# CITY PLAN COMMISSION STAFF REPORT

June 4, 2025

## Lineage Connect UR Redevelopment Project Name

CD-CPC-2025-00039  
Urban Redevelopment District

## PROPOSED ELEVATIONS

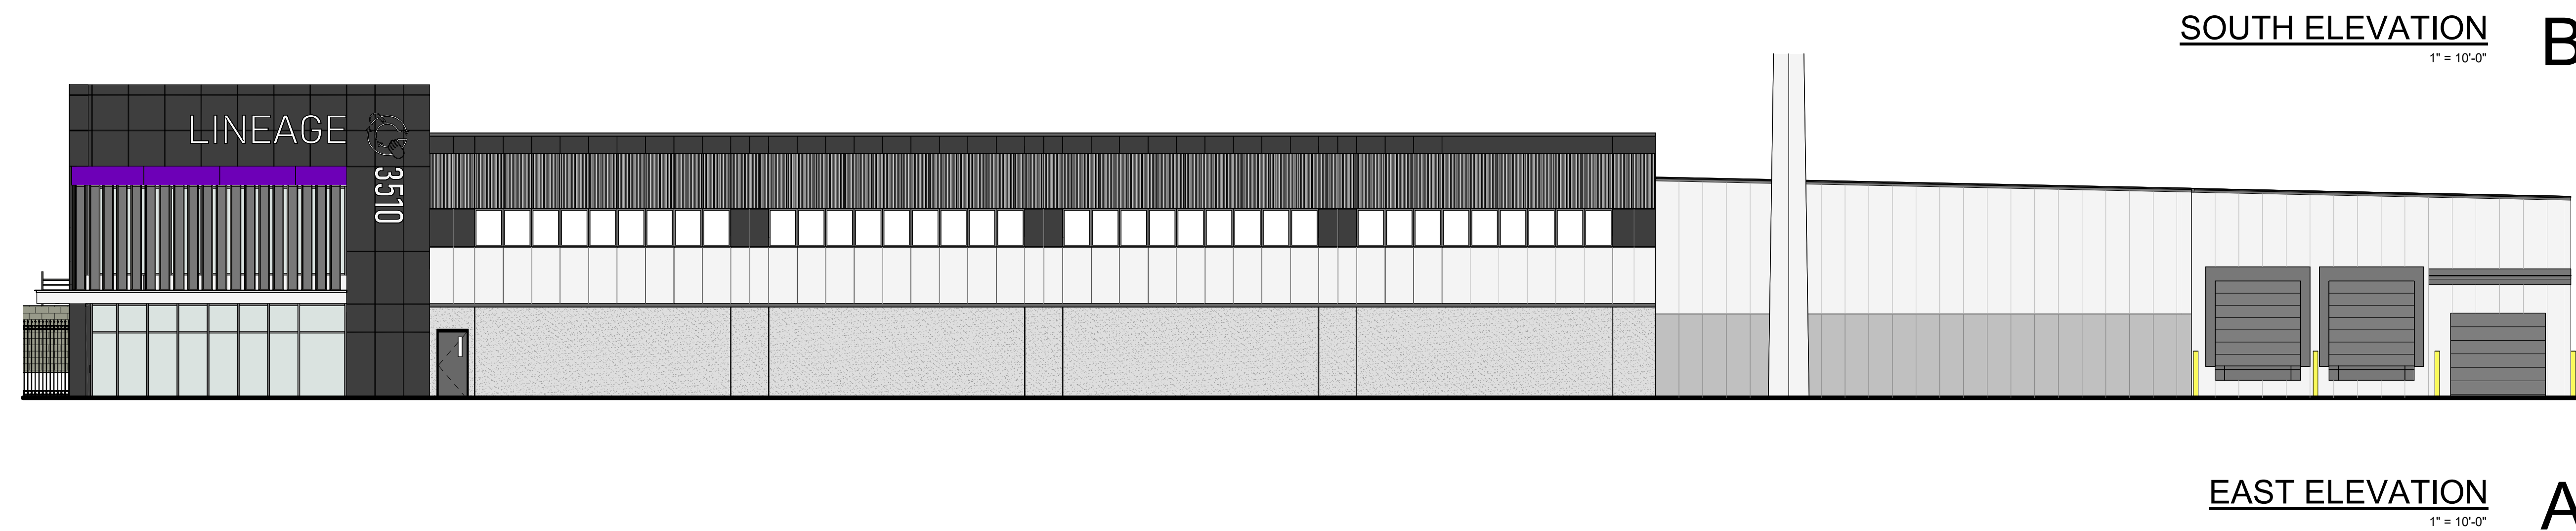
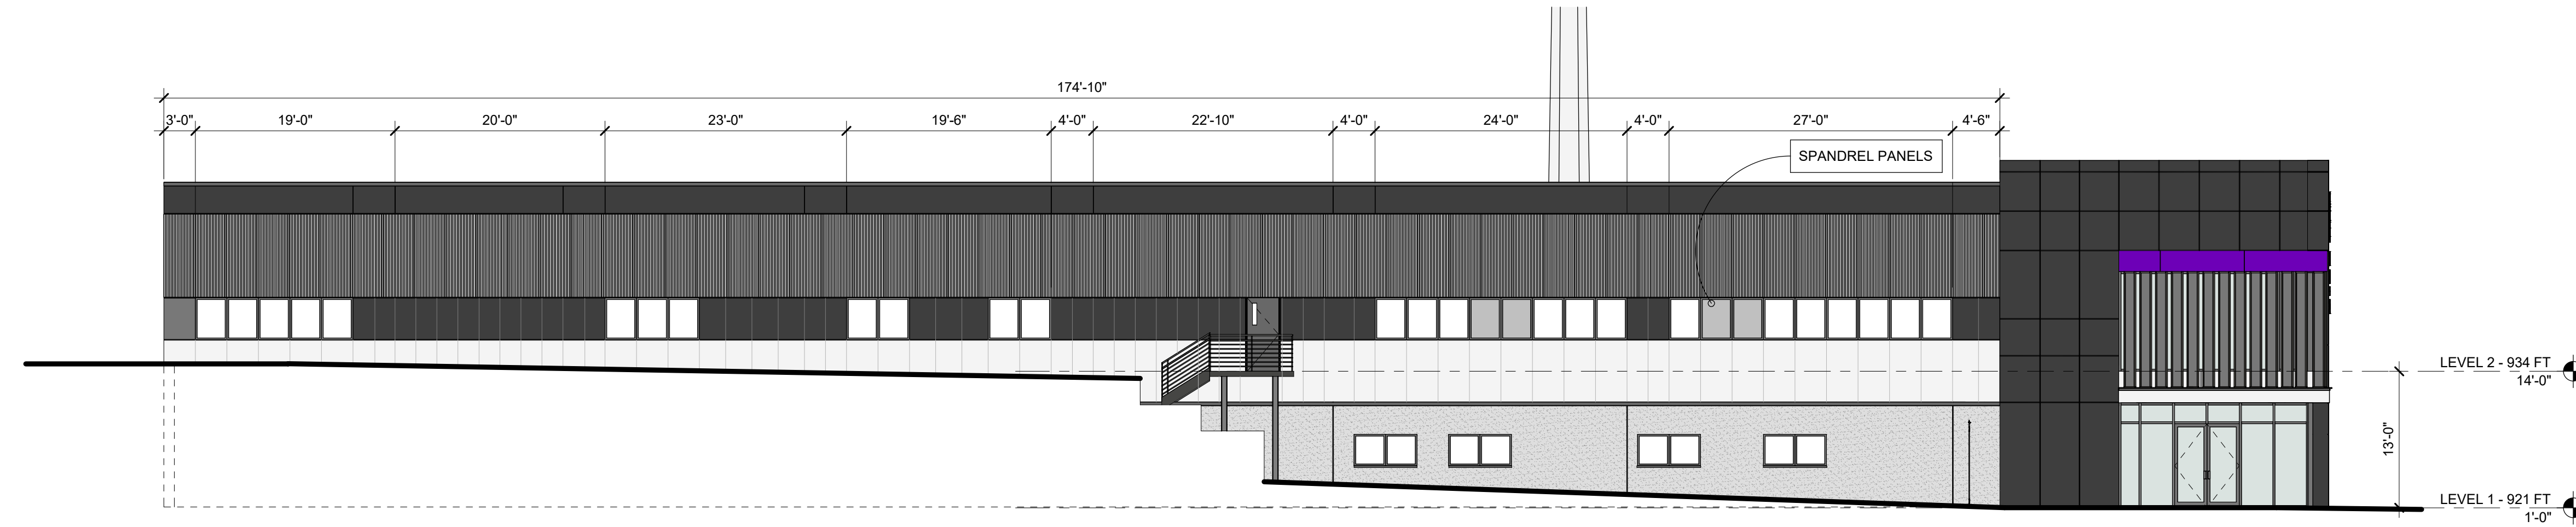
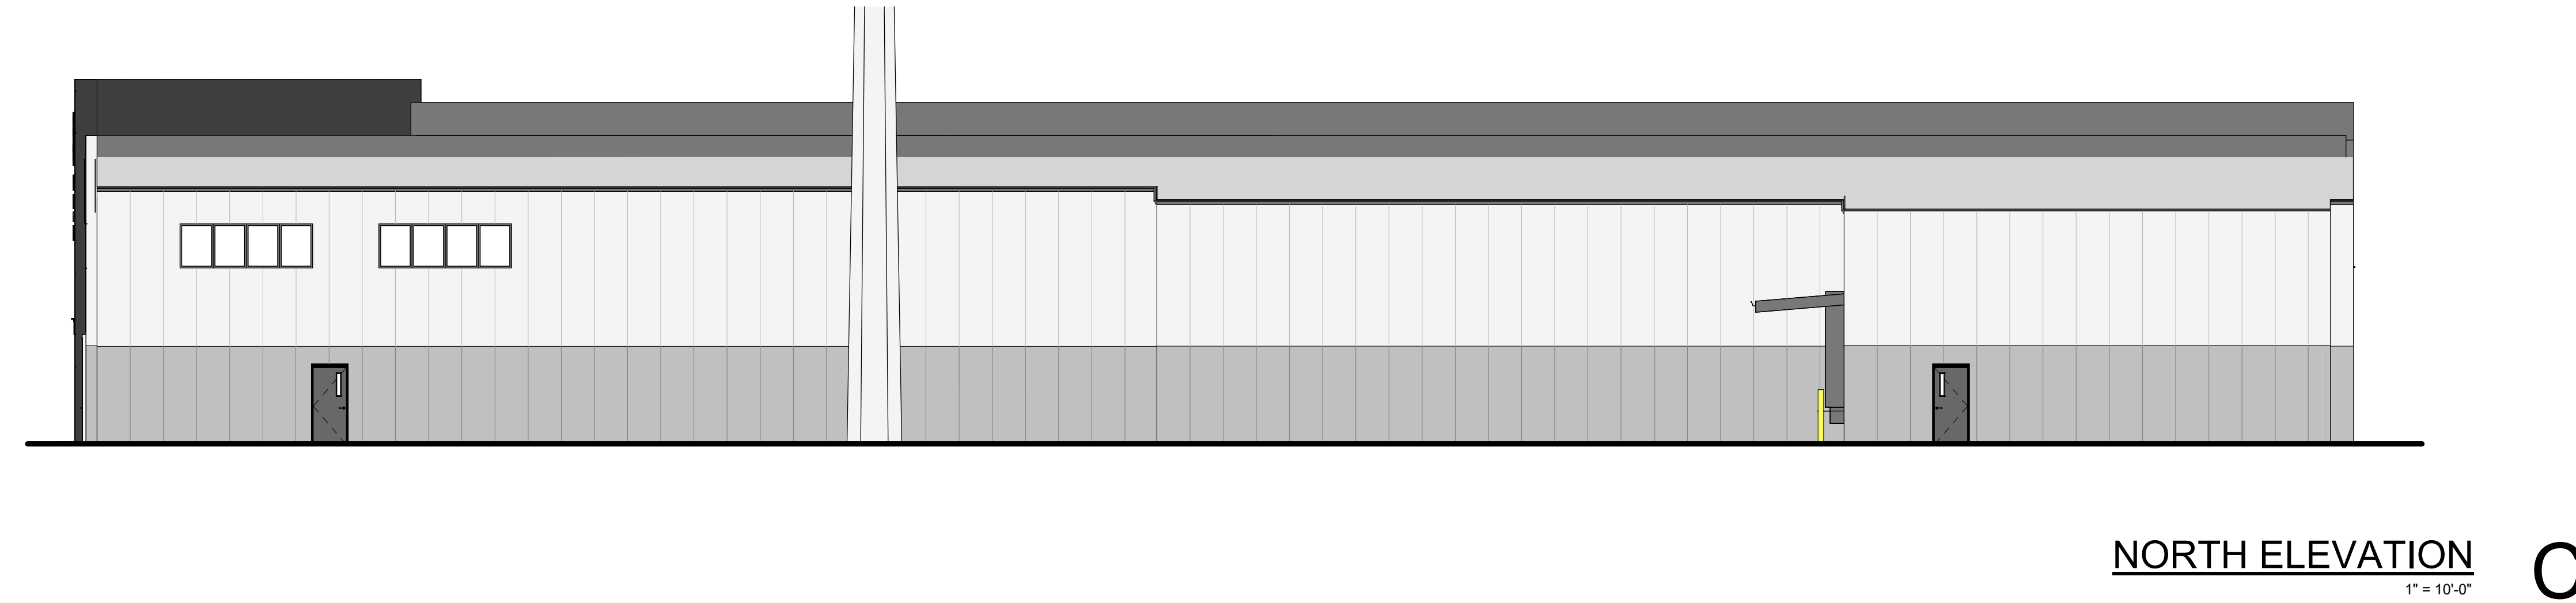
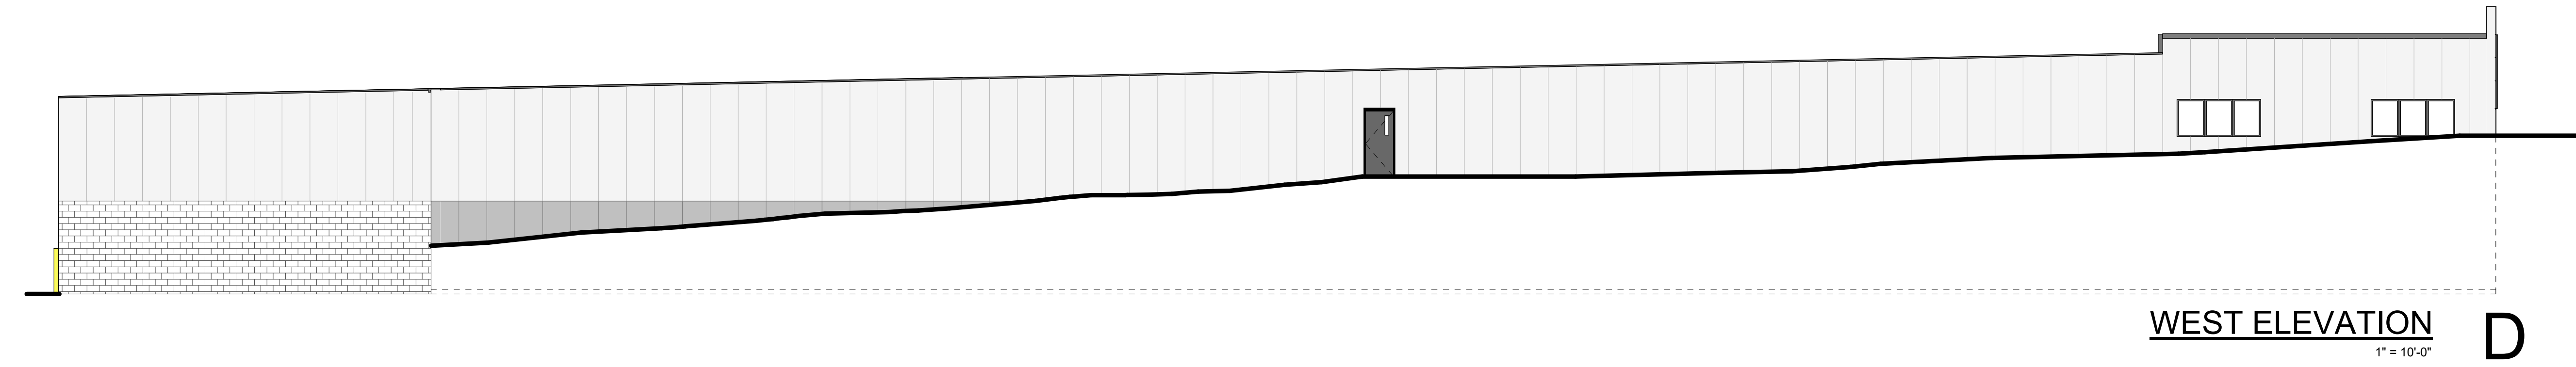
property. While the building is oriented closer to the street with a defined walkway from the sidewalk to the entrance, the expansive blank first floor façade facing Prospect Avenue does not align with the well-designed city goal in the KC Spirit Playbook nor the definition of a transit neighborhood node found in the ProspectUS Plan. Additional transparency lower to the ground would increase the perception of safety, and the inclusion of public art such as a mural on the blank wall would better align with the History, Arts, and Culture goal in the KC Spirit Playbook, and placemaking recommendations ProspectUS Plan. While energy efficient building materials are proposed, material colors and the selection of materials do not match the surrounding building materials found on commercial buildings along the Prospect Avenue corridor. Alignment with the KC Spirit Playbook, Area Plan design guidelines, and recommendations in the ProspectUS plan were provided but not considered to further increase the overall alignment of the project.”

20. All exterior building facade materials shall be denoted with percentages of the overall square footage of the material installed compared to the entire facade for each building facade on the elevations of the UR final plan.
